Objection to DC/26/0972 and DISC/26/0255

I object to DC/26/0972 (Appearance, Landscaping, Layout and Scale) and DISC/26/0255 (Biodiversity Enhancement Strategy) on the grounds of environmental law and NPPF non-compliance.

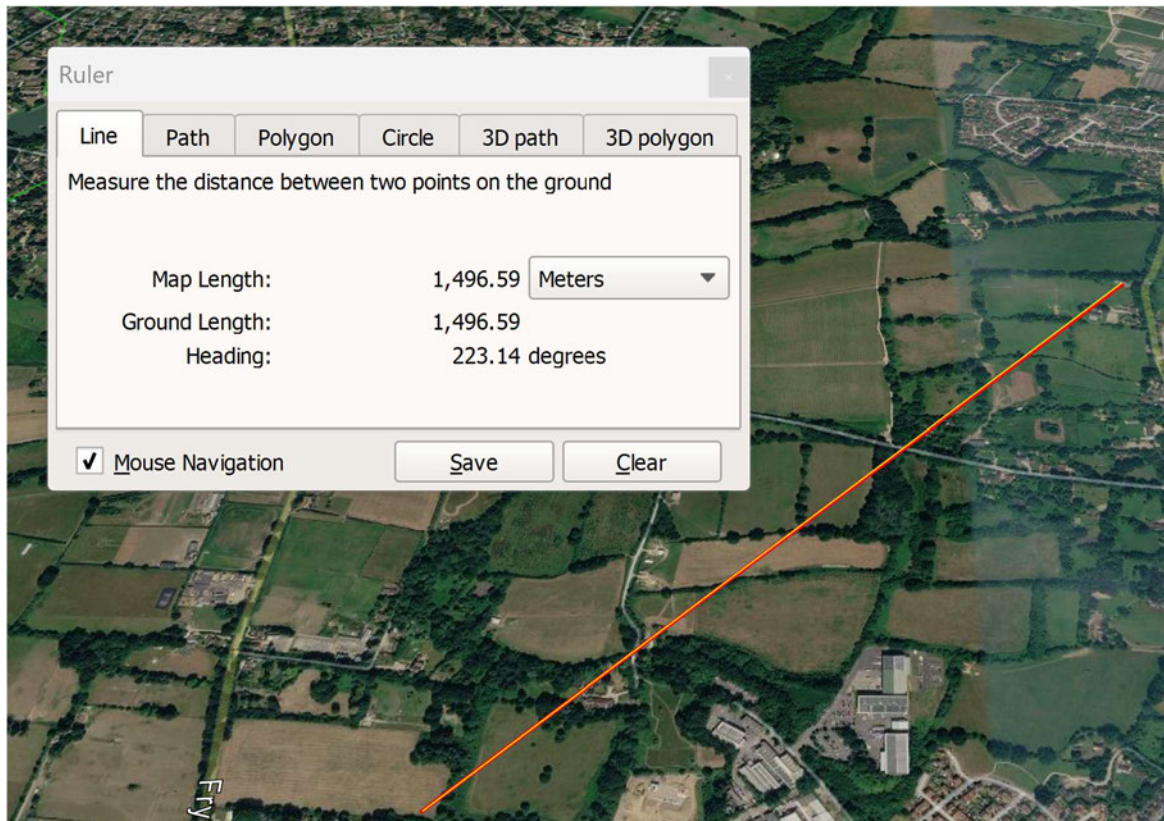
The eastern boundary is a hedgerow interspersed with mature trees – see the photo below taken from the adjacent field.. It will not provide contiguous, year-round screening. The current design will result in domestic and vehicle lights from the houses in the SE corner of the development being visible over a wide area to the North-East and East, especially after leaf-fall.
